## Planning Commission Staff Report

April 9, 2014  
Item 6.a.

- SUBJECT:** PUD-98 and P13-2518
- APPLICANT:** Keith Henderson for CarMax Auto Superstores
- PROPERTY OWNER:** Alameda County Surplus Property Authority

- PURPOSE:** Applications for PUD Development Plan and Sign Design Review to construct an automobile dealership consisting of an approximately 11,783-square-foot sales and presentation building, an approximately 45,000-square-foot service building, an approximately 3,930-square-foot quality control building and non-public car wash, vehicle sales display area, project signage, and related site improvements on approximately 19.66 acres of the Auto Mall site at Staples Ranch.

**FIGURE 3:** Proposed Site Plan

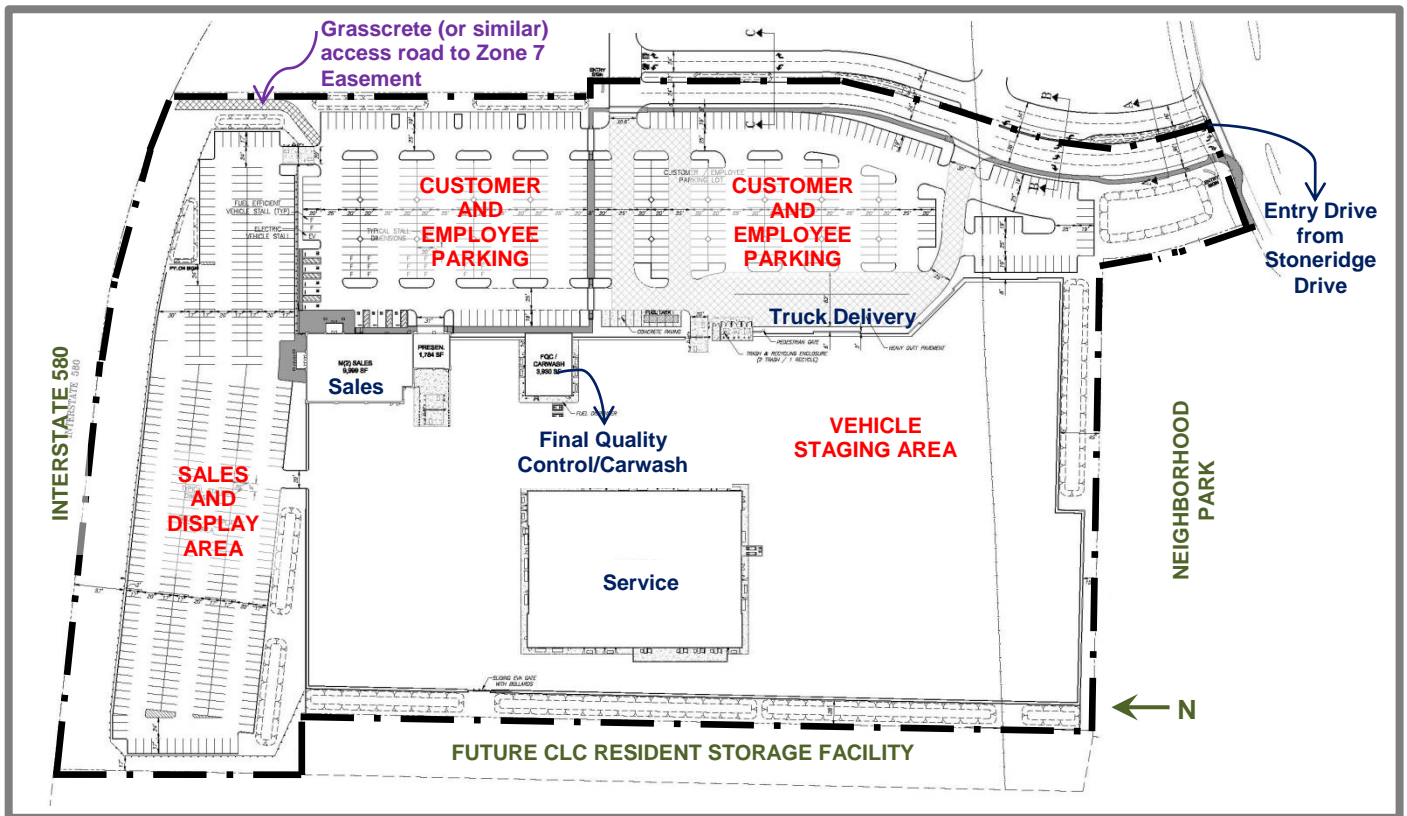
The site plan has been designed to allow access to the site via an entry road from Stoneridge Drive. The entry drive has two lanes to enter the project site (or adjacent future development) and three lanes for exiting. A left turn pocket allows access to the project site's southern driveway. The access drive continues further north and ends at a proposed stop sign intersection where in-coming visitors would make a left turn into the subject site (or a right-turn into the future auto dealer's site). Generally, staff finds the site plan acceptable.

As mentioned previously, circulation on the site is facilitated by two driveways from the entry drive. Drive aisles in the customer/employee parking lot meet the minimum standards in the PMC. Areas not accessible to customers include the display area and the vehicle staging area. Since only employees will be able to drive cars within these areas, staff finds the circulation acceptable.

**FIGURE 8:** Proposed Landscaping Plan

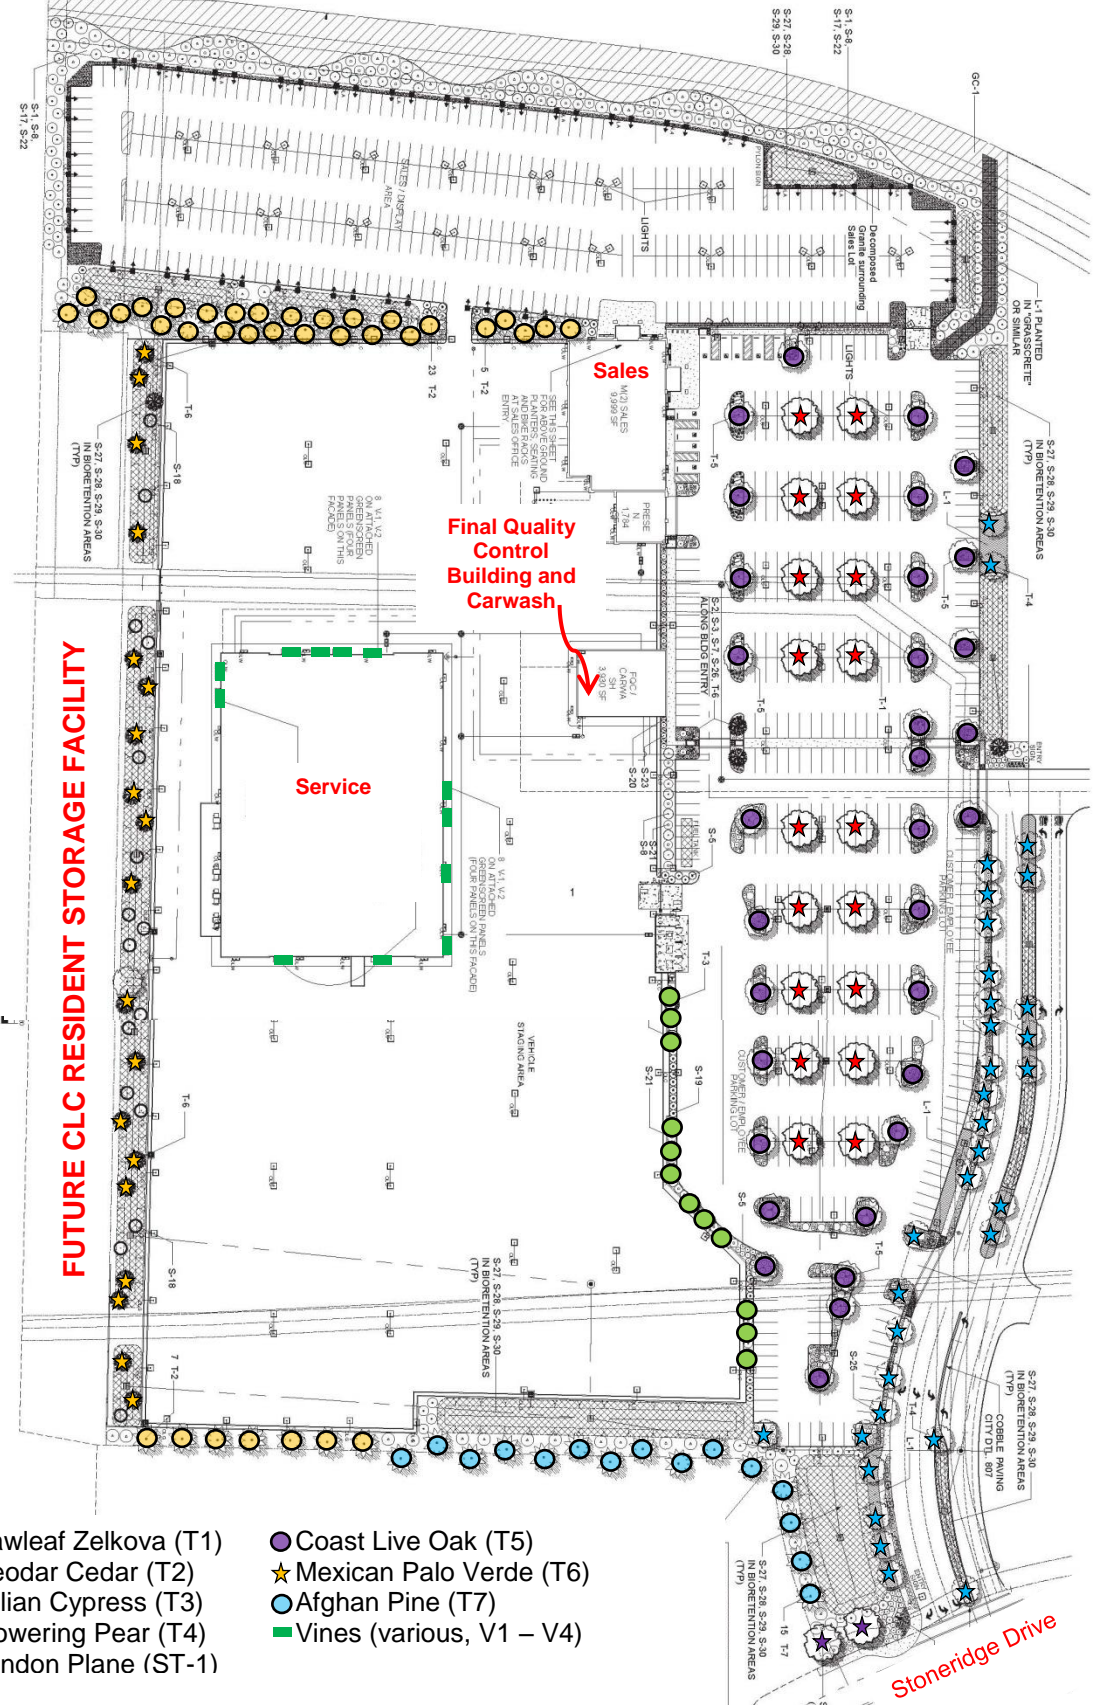
Since there are no trees on the subject site, none will be removed. The landscaping plans provided as part of Exhibit B include a preliminary planting plan that incorporates both evergreen and deciduous tree species. Various types of shrubs and groundcover are located within bioretention areas and parking lot planter islands. According to the preliminary plant schedule, all trees are proposed to be 24-inch box size. Since the February 12, 2014, Workshop with the Planning Commission, the applicant has increased the number of Deodar cedar trees located within the planter area directly north of the vehicle staging area to further screen the service building, modified the tree species in the landscape planter diamonds to Sawleaf Zelkova instead of Arizona Ash, and identified the two street trees shown as London Plane. Staff believes that the species, quantities, and sizes of the proposed landscaping for the site are adequate.

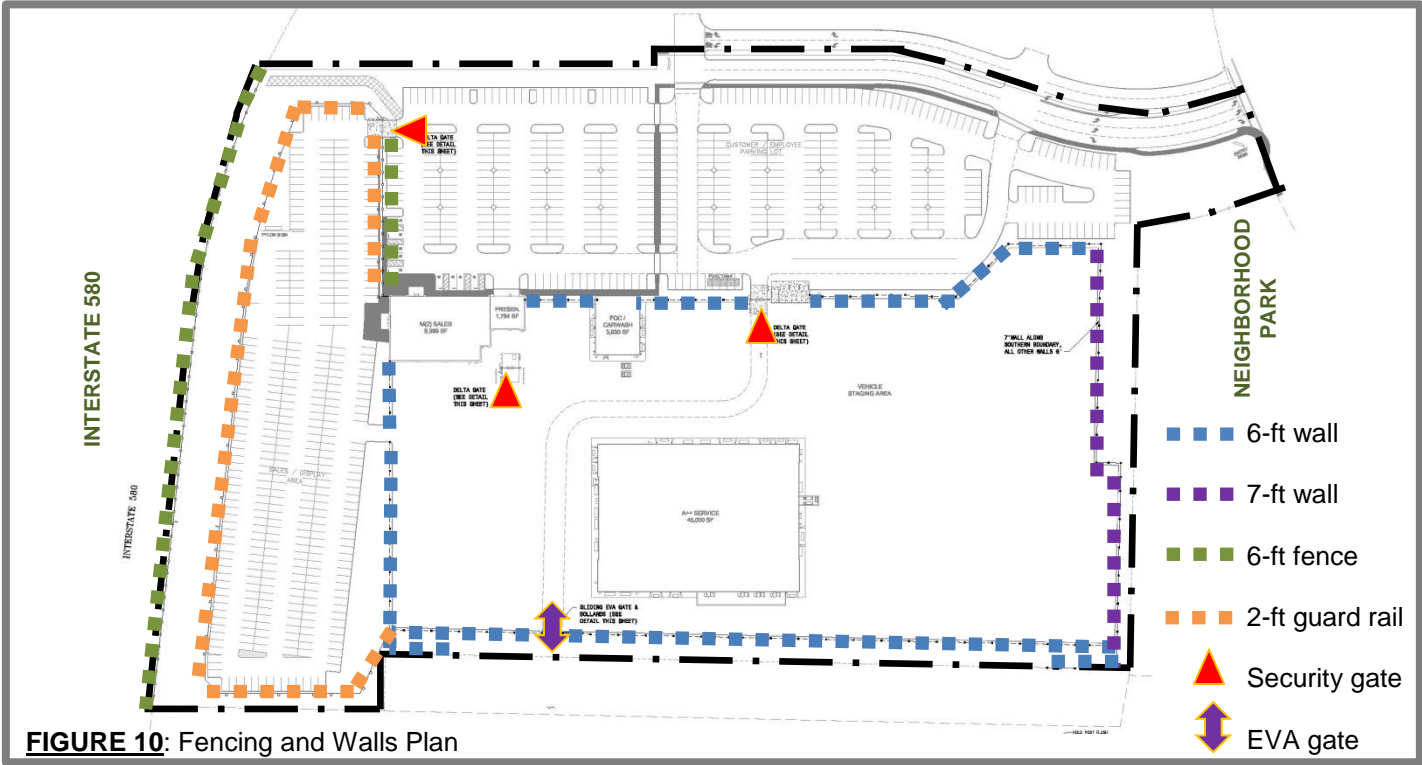
- **Wall Around Vehicle Staging Area** – A 6-foot tall (7-foot tall along the southern boundary of the vehicle staging area, adjacent to the Neighborhood Park) stucco wall is proposed around the vehicle staging area (blue and purple in Figure 10). The wall is proposed to extend to the property line to secure the bioretention area located adjacent to the western property line. The wall will consist of stucco veneer with a light earthtone color on the “top half” and a dark earth tone color on the “bottom half,” with a 6-inch tall white cap along the top of the wall and top of the pilasters. The wall “jogs” in and out where it abuts the customer/employee parking lot to decrease the appearance of a single plane.

- **Ornamental Fence** – A 6-foot tall black ornamental fence is proposed along the property boundary adjacent to Interstate-580, and between the sales/display and customer/employee parking lot (shown in green in Figure 10).

- **Guard Rail** – An approximately 2-foot tall guard rail is proposed around the sales/display parking area (shown in orange in Figure 10).
- **EVA Gate** – A sliding gate made of tube steel framing and infill panels and removable bollards are proposed at the emergency vehicle access easement opening at the western property line of the project site (purple arrow).

- **Security Gate** – A total of 3 security gates (identified as “delta gate” on the project plans) are proposed (red triangles in Figure 10). Two of the three security gates will be visible to customers, as one is proposed north the trash/tire enclosure and the other is proposed between the sales/display area and the customer/employee parking lot (the third is within the vehicle staging area). The security gate is described as an embassy-style security gate in the project description, and is controlled by employees with a key-card.

**FIGURE 11:** Proposed Pylon Sign and Monument Sign at Entry Drive

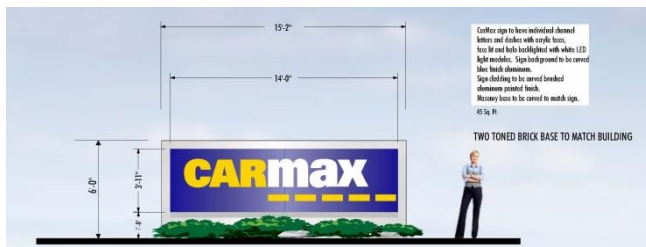
Two ground-mounted signs are part of the Exhibit B plans for the Planning Commission's review: the freeway-oriented pylon sign and the monument sign at the entry drive. Given the conformance to the pylon sign's height maximum in the Specific Plan Amendment, staff is supportive of the sign as long as only one type of illumination is used, the background of the cabinets remains opaque (such that only sign copy or logos illuminate), and future dealers submit their cabinet proposal subject to review by the Director of Community Development prior to permit issuance. Staff also acknowledges that while the applicant has shown the future cabinets to be blue on Exhibit B plans, future auto dealers will likely want to incorporate their own corporate color for the sign background, and thus the cabinets will not have the same blue background as depicted. Overall, staff finds both the pylon sign and the proposed monument sign to be acceptable.
